Model: Model TH-C1	Date: 12-Apr-05	No.: RB156001a
--------------------	-----------------	----------------

Subject: Firmware History - PS3		Prepared by: H.K.	
From: 1st Tech. Support Sec. Service Support Dept.			
Classification:	<input type="checkbox"/> Troubleshooting	<input type="checkbox"/> Part information	<input type="checkbox"/> Action required
	<input type="checkbox"/> Mechanical	<input type="checkbox"/> Electrical	<input type="checkbox"/> Service manual revision
	<input type="checkbox"/> Paper path	<input type="checkbox"/> Transmit/receive	<input type="checkbox"/> Retrofit information
	<input checked="" type="checkbox"/> Other (Firmware History)

Model: Model TH-C1		Date: 17-May-05	No.: RB156002
Subject: Notes for Installation		Prepared by: H.K.	
From: 1st Tech. Support Sec. Service Support Dept.			
Classification:	<input type="checkbox"/> Troubleshooting	<input type="checkbox"/> Part information	<input type="checkbox"/> Action required
	<input type="checkbox"/> Mechanical	<input type="checkbox"/> Electrical	<input checked="" type="checkbox"/> Service manual revision
	<input type="checkbox"/> Paper path	<input type="checkbox"/> Transmit/receive	<input type="checkbox"/> Retr

9. Attach the clamps [A] and put the harness inside the clamps.

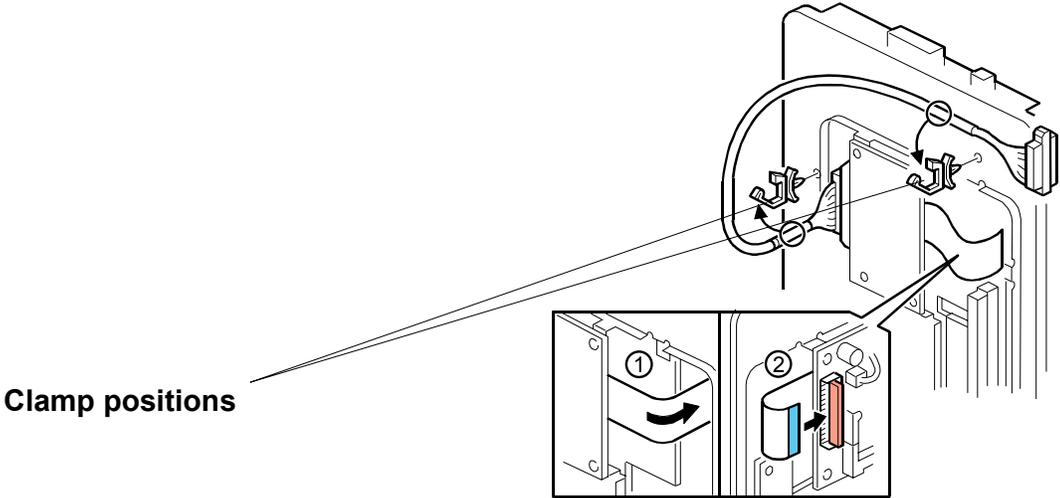
- **Service Manual: Step 9**, pg. 1-10

Please add the following important note to Step 9

Important: Make sure to attach the clamps in the two positions shown in the illustration. If you do not do this, you cannot attach the flat cable.

B0519911: Washer – 20 pcs/set

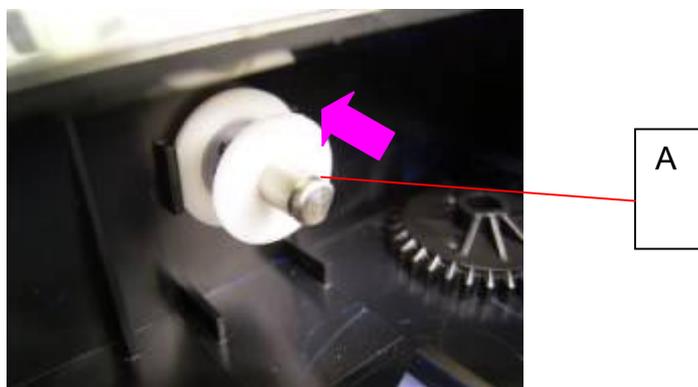
5. Attach the new washer (A) to the shaft.

Important: The washer fits tightly around the shaft, but **DO NOT** change the size of the D-cut.

Photo No.1

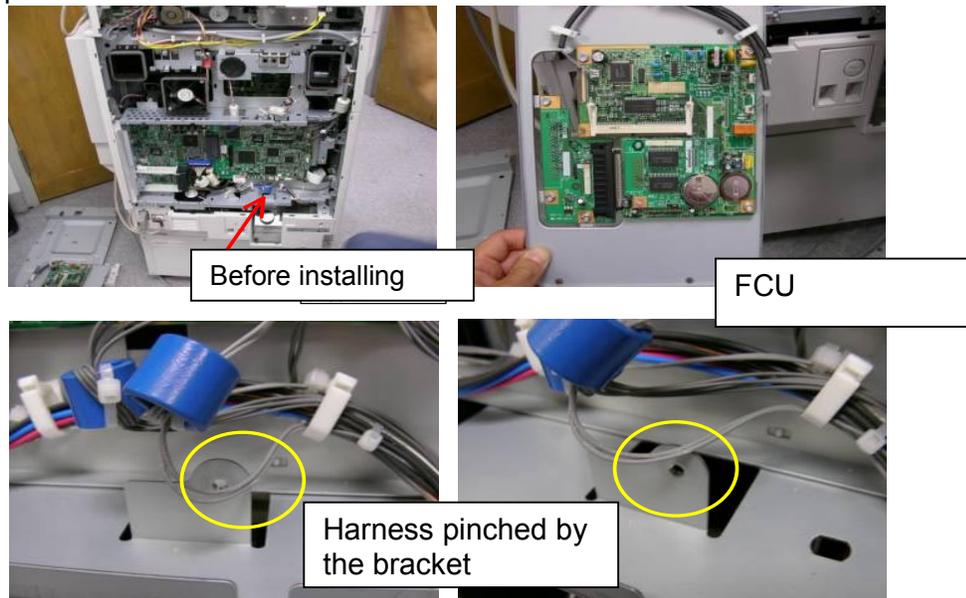
Make sure not to pinch the harness while lowering the harness connected to BICU from the PSU (as shown in photo No.2) when you put back the FCU.

Replace the PSU and correct the pinched harness. Replace the harness if it is damaged.

Photo No.2

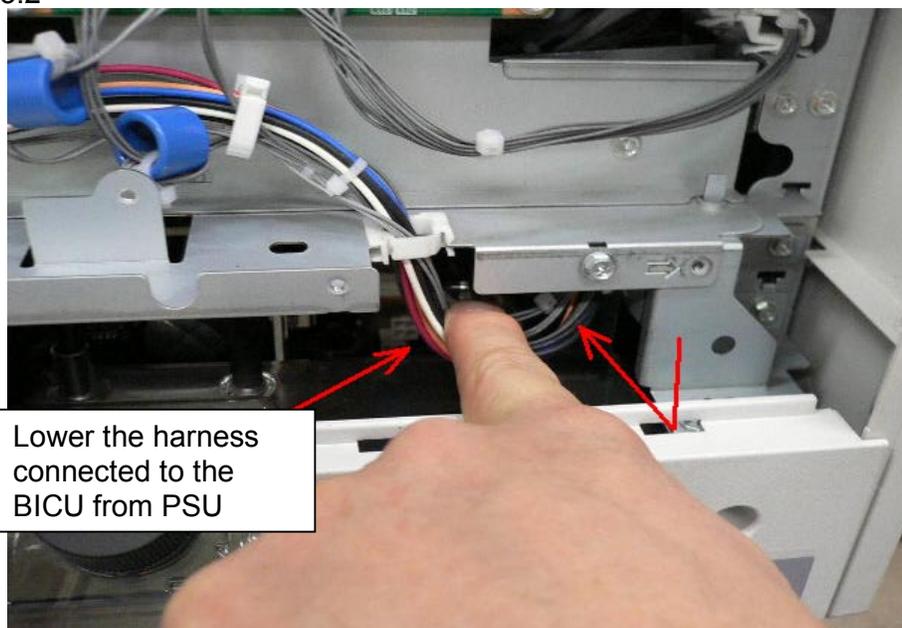
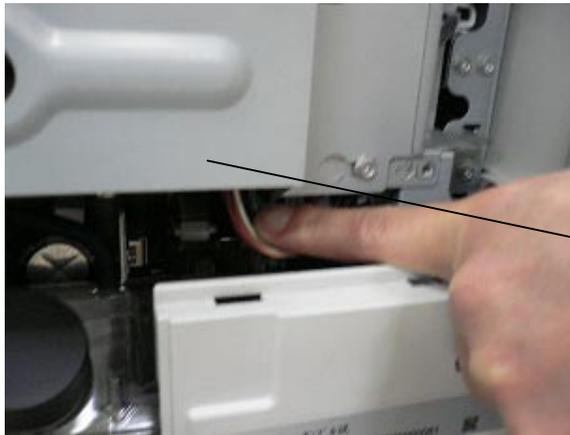
Lower the harness as shown with the red arrow when you put back the controller box cover.

Photo No. 4: The "BICU Harness Protect Plate Mylar" (B1545881)

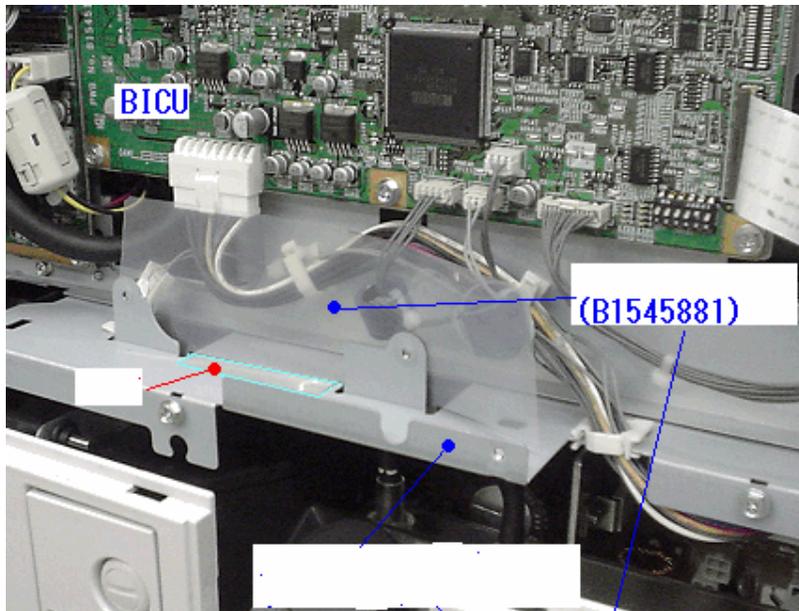
As a final solution, a Mylar was added to the control unit bracket (see Photo No. 4).

Action in the Field

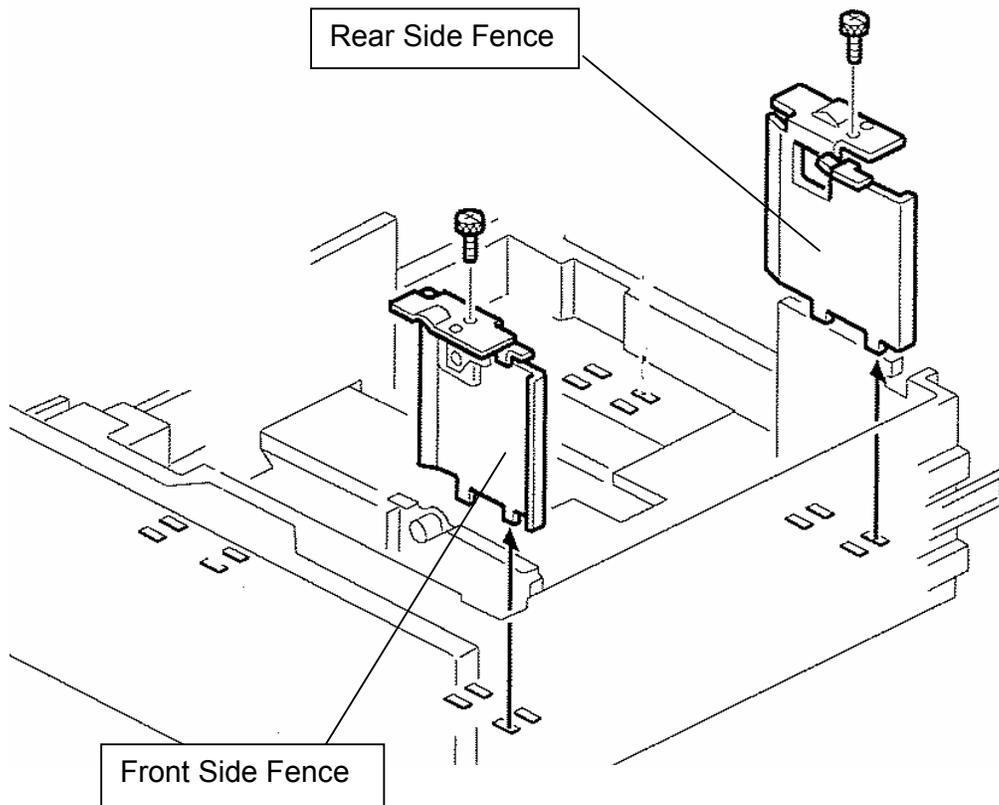
When the paper stack is moved from the left to the right in the LCT, the first sheet of the paper stack in the LCT jams, or noise occurs and the paper is not fed.

1. Replace the front side fence with **B1809902** (production line temporary solution).
- Or,**
2. Replace the front side fence and rear side fence with **B6002645** and **B6002655**.

Production line

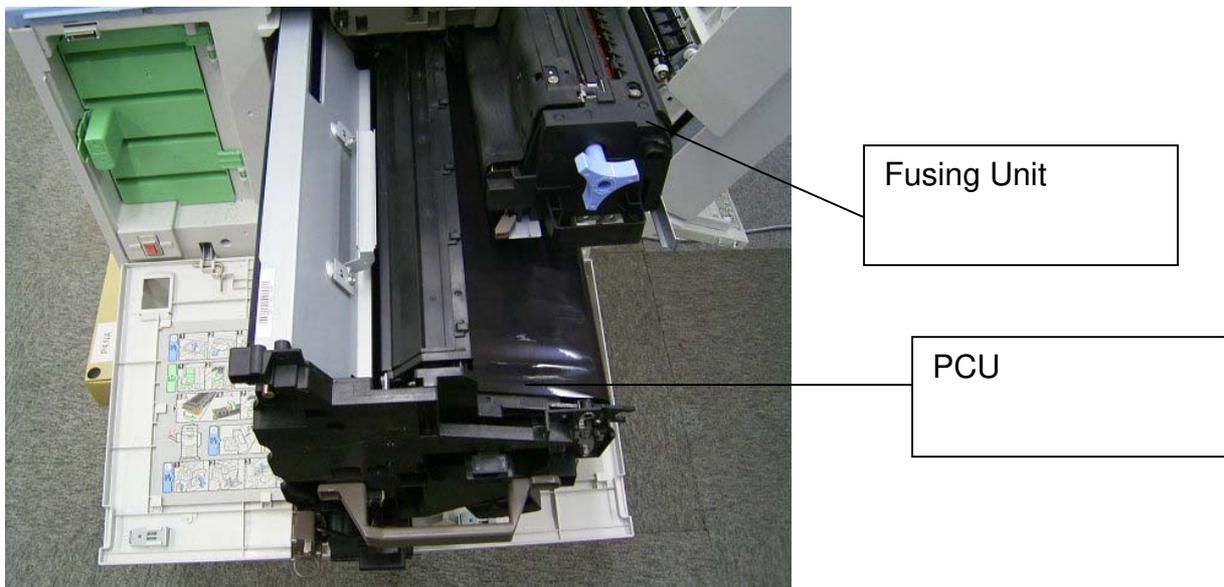
The height adjustment mechanism was discontinued. The front side plate is now only one part.

Transfer Section 3 (pg. 28)

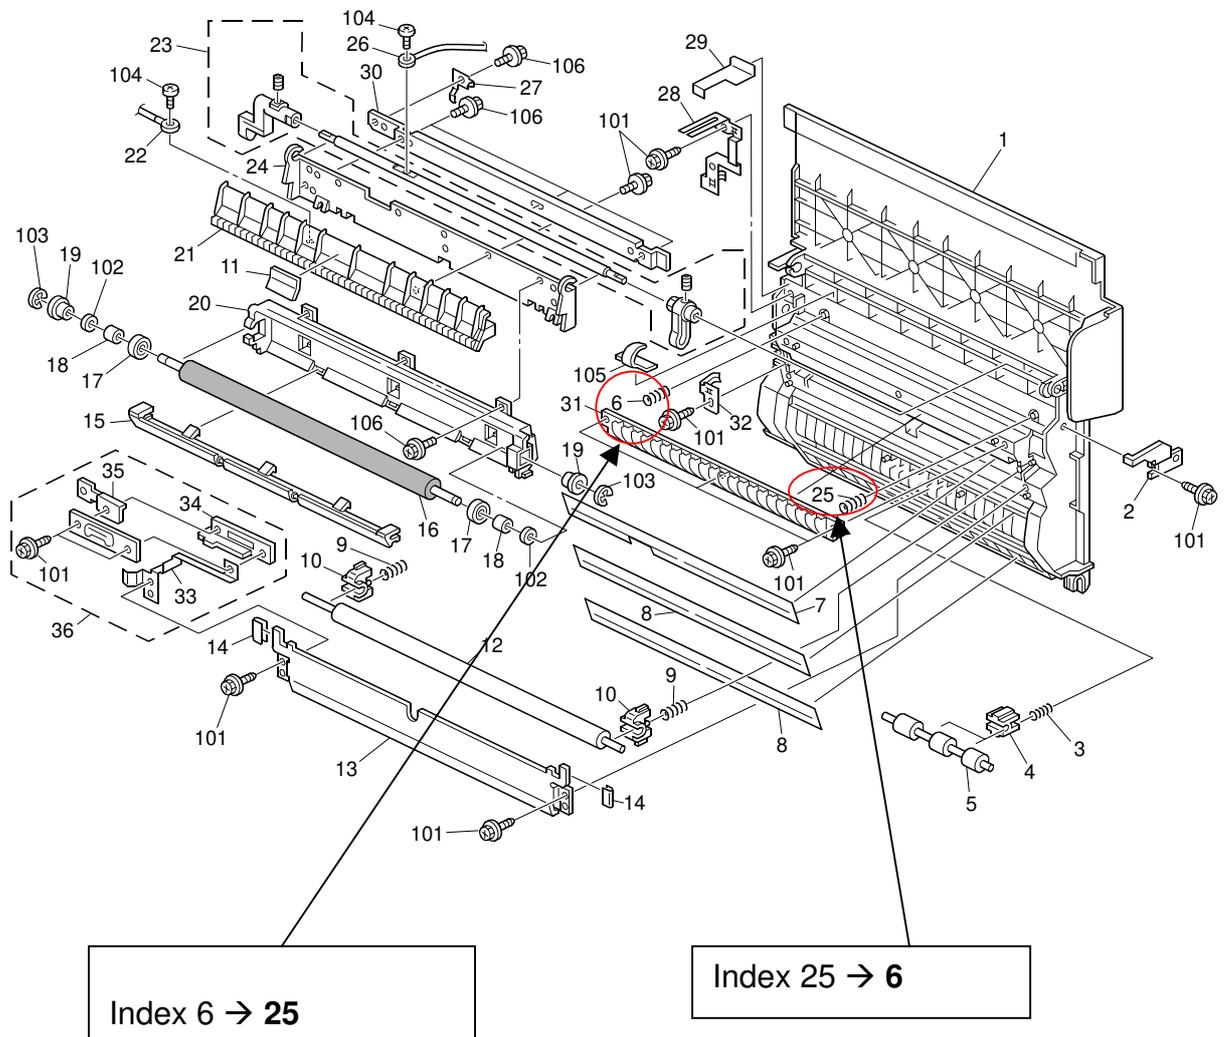
Change/Reason: The index numbers in the illustration were corrected.
